RS-14-173

Quad Cities Nuclear Power Station, Units 1 and 2
Renewed Facility Operating License Nos. DPR-29 and DPR-30
NRC Docket Nos. 50-254 and 50-265

Subject: Response to Request for Additional Information Regarding Fukushima Lessons Learned - Flood Hazard Reeevaluation Report

Regarding Fukushima Lessons Learned - Flood Hazard Reevaluation Report

Figure 1.1 - Flood Event Duration Parameters (Elevations in MSL 1912)

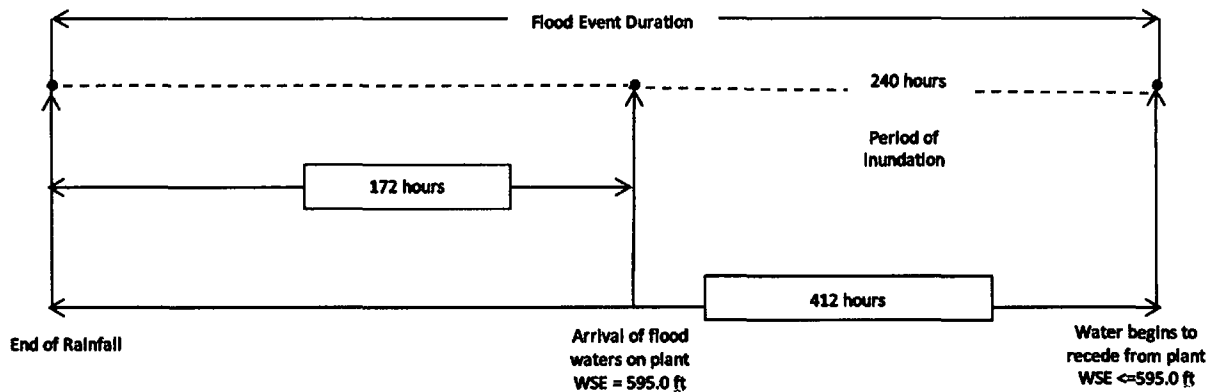
Request: Provide the applicable flood event duration parameters (see definition and Figure 6 of the NRC interim staff guidance document JLD-ISG-2012-05, "Guidance for Performing an Integrated Assessment," November 2012 (ADAMS Accession No. ML12311A214), associated with mechanisms that trigger an integrated assessment using the results of the flood hazard reevaluation. This includes (as applicable) the warning time the site will have to prepare for the event (e.g., the time between notification of an impending flood event and arrival of floodwaters on site) and the period of time the site is inundated for the mechanisms that are not bounded by the current design basis. The licensee is also requested to provide the basis or source of information for the flood event duration, which may include a description of relevant forecasting methods (e.g., products from local, regional, or national weather forecasting centers) and/or timing information derived from the hazard analysis.

Flood event duration parameters for the controlling flooding mechanism for elevations above 595.0 feet MSL 1912 are calculated based on the shape of the PMF hydrograph. Flood event duration parameters for the controlling flood causing mechanism (PMF+ hydrologic dam failure) are summarized as follows:

1. The flood duration from the end of the PMP to elevation 595.0 feet MSL 1912 is 172 hours according to the HEC-RAS output time series table for the controlling PMF simulation (PMF + hydrologic dam failure).
2. The duration of inundation above elevation 595.0 feet MSL 1912 is 240 hours according to the HEC-RAS output time series table for the controlling PMF simulation (PMF + hydrologic dam failure).

As identified by JLD-ISG-2012-05, the critical warning time, inundation time, and recession time for the controlling flooding mechanism (PMF+ hydrologic dam failure) are provided in Figure 1.1 and Table 1.1. Timing parameters for other analyzed flood causing mechanisms are summarized in Table 1.1 as well.

Figure 2.1: HEC-RAS Cross-Section Locations (Calculation # QDC-0085-S-1991, Attachment 1, Figure 15)

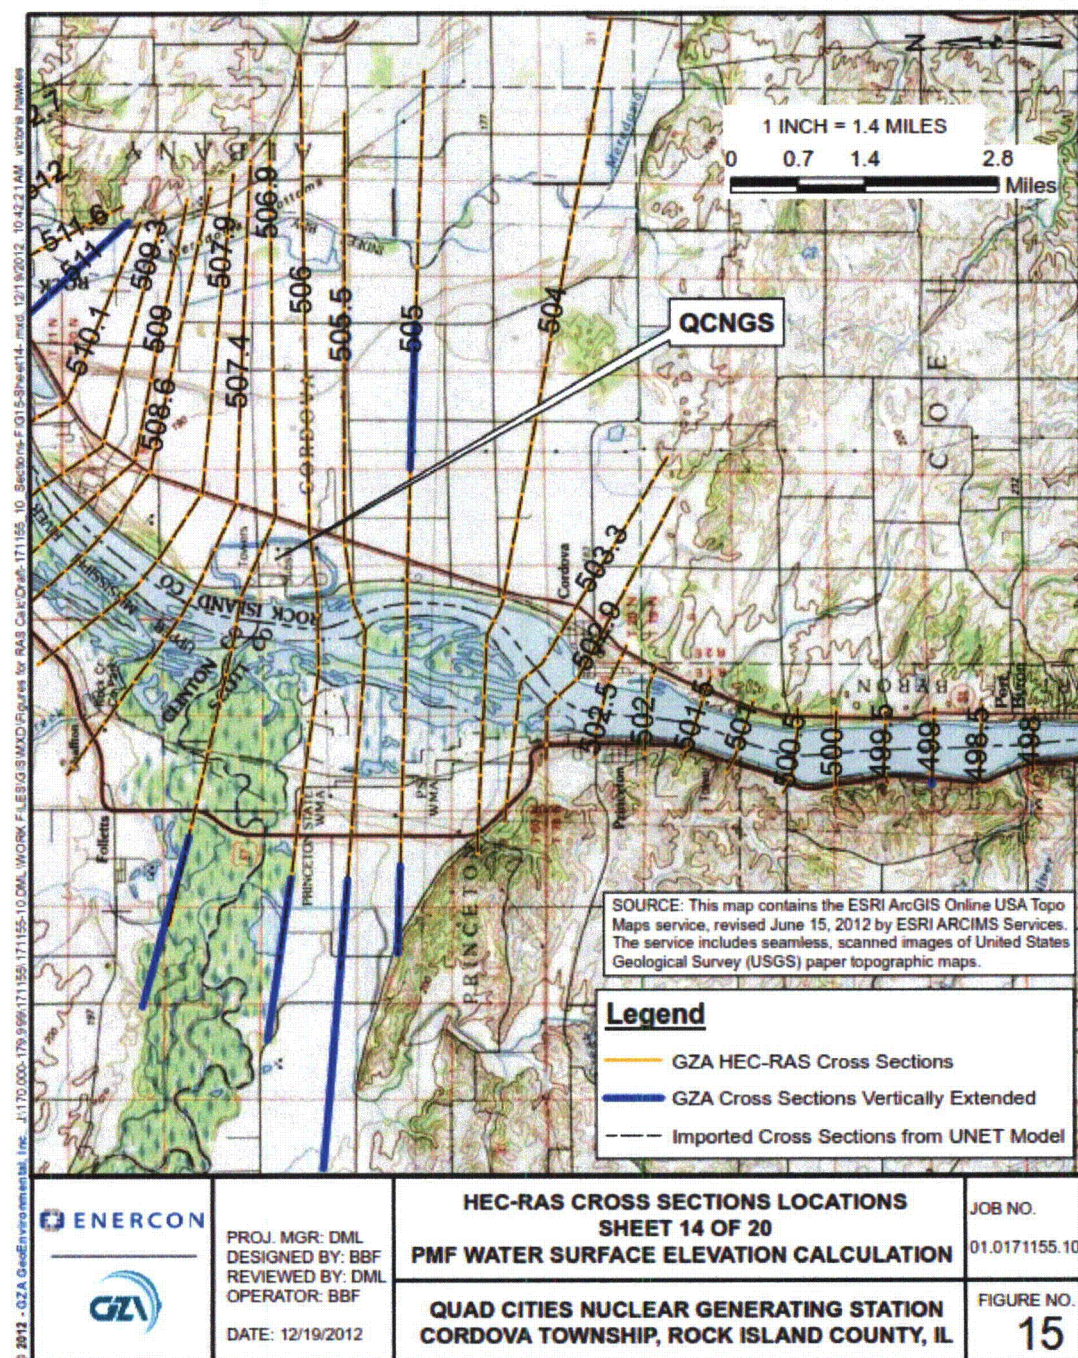
Request: Provide the flood height and associated effects (as defined in Section 9 of JLD-ISG-2012-05) that are not described in the flood hazard reevaluation report for mechanisms that trigger an integrated assessment. This includes the following quantified information for each mechanism (as applicable):

- Hydrodynamic loading, including debris;
- Effects caused by sediment deposition and erosion (e.g., flow velocities, scour);
- Concurrent site conditions, including adverse weather; and
- Groundwater ingress.

The Mississippi River is a navigable water body and, therefore, the potential for a barge to impact critical structures during the PMF event was assessed. As shown in Table 2.1, velocities in the main channel are much higher than overbank velocities at the site. Also, as shown in Figure 2.1, the plant is located in the left (looking downstream) overbank and inner curve of bend in the river channel. The velocity differential and configuration of the river at the site indicates that inertia alone would keep floating barges in the main channel, making any direct or indirect strike on critical structures not credible. Furthermore, topographic features between the site and river would protect the plant from barge impacts.

Figure 1 – Overtopped Security Barriers during FLO-2D LIP Model Run

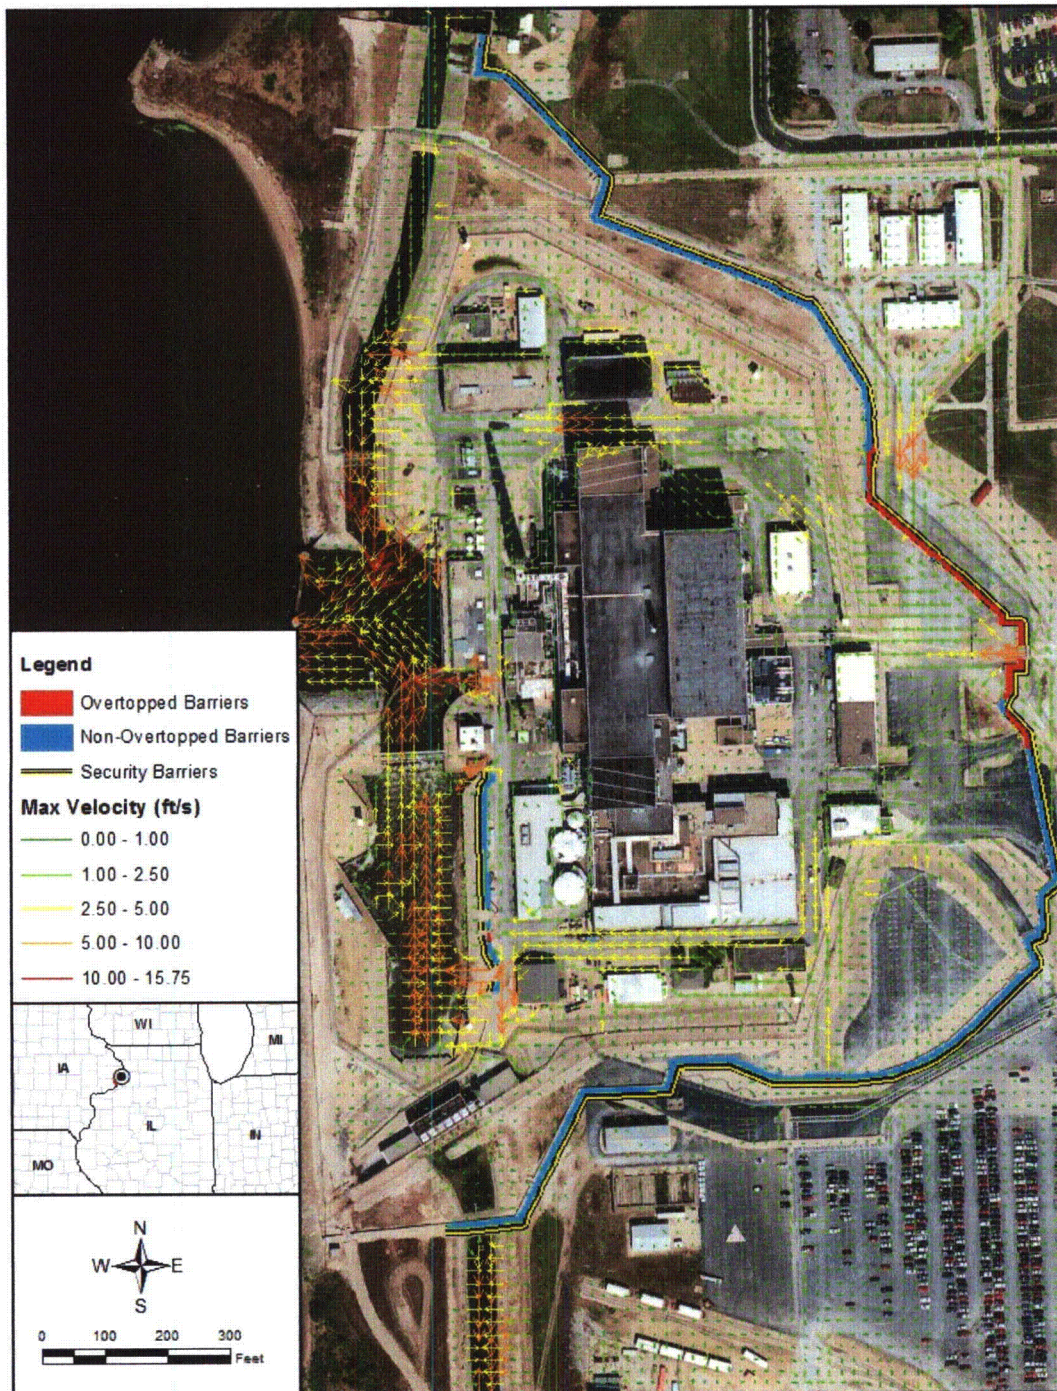
Request: Provide justification for modeling the flow over concrete security barriers using the FLO-2D levee function (i.e., as flow over a broad-crested weir with a fixed weir coefficient of 2.85), including a discussion of any physical characteristics which prompt such a selection and any sensitivity analysis that was performed.

The levee feature was used to represent the concrete jersey barriers and concrete blocks in the FLO-2D model to account for the security barrier's effects on local drainage patterns. The use of the levee feature allowed for modeling of the gaps between the security barriers to accurately represent potential flow paths around and over the structures. Weir flow will occur until the tailwater depth is 85% of the headwater depth, and at that point the model will calculate the exchange across the levee using the difference in water surface elevation. This modeling approach allows for better representation of the security barrier compared to changing the ground elevation of each individual grid element to reflect the top elevation of the security barrier. Furthermore, the breadth of the security barrier (concrete block width and jersey barrier configuration) is more representative of a broad crested weir and justifies the use of the broad crested weir coefficient for estimating overtopping flow in this analysis. In addition, only a limited segment of the security barriers is overtopped during the LIP event, as shown in Figure 1.

Figure 1 – Smethport, PA July 1942 NWS transposition limits with notes detailing constraints

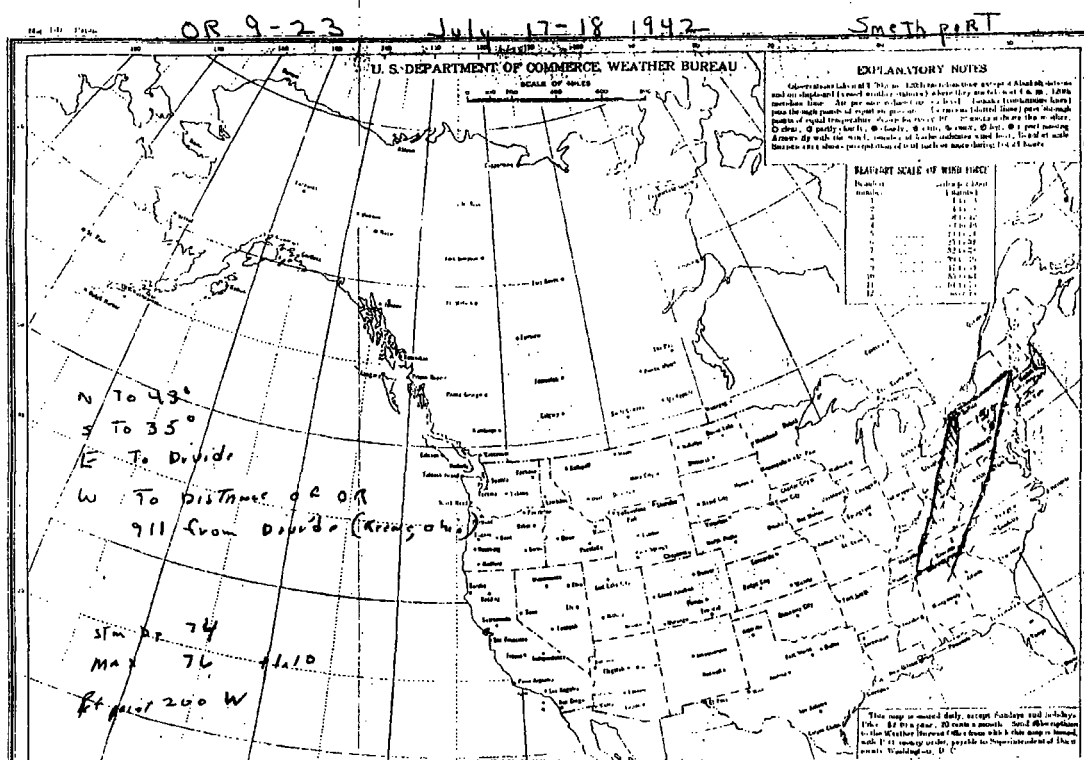
- A detailed description of the techniques and databases used, including storm selection. Describe any difference between techniques and databases used in the current analysis and those used in HMR 51.
- A detailed comparison between PMP results in HMR 51 and the FHRR analysis for those areas and duration common to both analyses. Include an explanation for differences that may exist.

A specific example of the implicit transpositioning that effects HMR 51 PMP values across the entire domain is demonstrated by the maximized values of the Smethport, PA July 1942 storm and how those values were enveloped. The NWS explicitly states that this storm should only be transpositioned east to the crest of the Appalachians, south to 35°N , north to 43°N and west along the first upslopes of the Appalachians (Figure 1). However, the PMP isolines across the entire region covered by HMR 51 envelope the data from this storm, thereby allowing a storm which is not transpositionable to much of the domain to control PMP values inappropriately. This is evidenced by comparing all storms used in HMR 51 to the PMP values over the regions where they are transpositionable and noting that no storm data supports the values provided except the maximized Smethport storm.

Figure 12.1 – Grid points used in the study with QCNS watershed and sub-basins delineated for reference

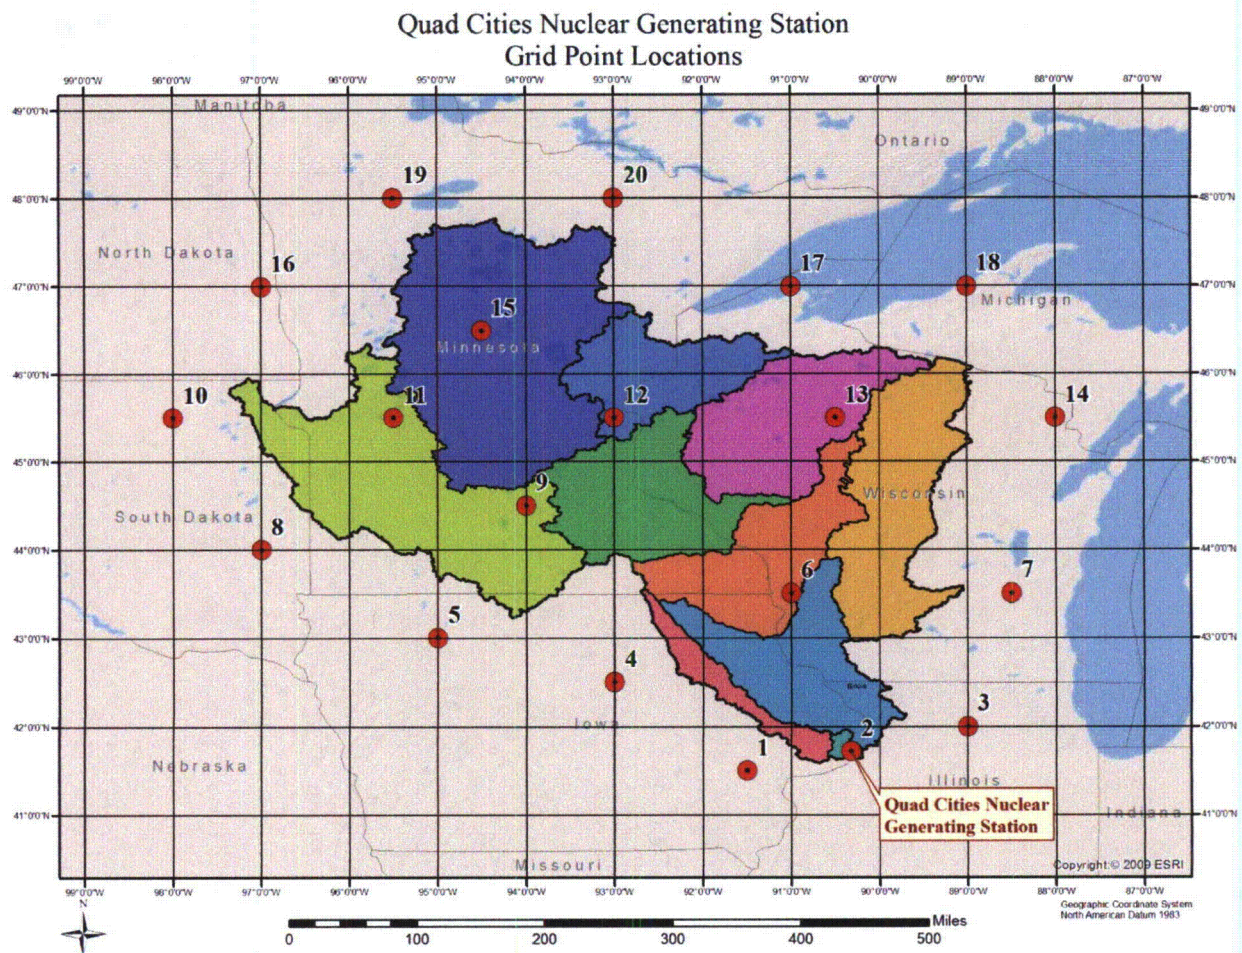
- A detailed comparison between PMP results in HMR 51 and the FHRR analysis for those areas and duration common to both analyses. Include an explanation for differences that may exist.

A direct comparison to HMR 51 PMP values for duration from 24- through 72-hours and area sizes from 1000- through 20,000-square miles is provided at each grid point analyzed during the study in Table 12.1-12.3. In the tables, values greater than zero represent reductions from the HMR 51 values and values less than zero represent increases from the HMR 51 values. Figure 12.1 displays the grid point locations used in this study and referenced in the Tables 12.1-12.3. Comparisons are only directly valid at these area sizes and durations because the storms used in this study to compute PMP values were of the storm type relevant for producing PMF over large area sizes and long durations. Therefore, short duration, high intensity storms (MCCs and thunderstorms) were not included in the analysis. This is because those storm types are unique and would not co-occur with large scale, long duration storms. Therefore, there should not be a comingling of storm types that would result in a PMP design storm which is not physically possible, as this would violate the HMR definition of PMP. Comparisons for cool-season PMP values are not possible because no explicit cool-season PMP values exist in HMR 51. HMR 52 does provide seasonality adjustments which can be applied to HMR 51 all-season PMP values. However, these data do not result in true cool-season PMP, as they are a result of
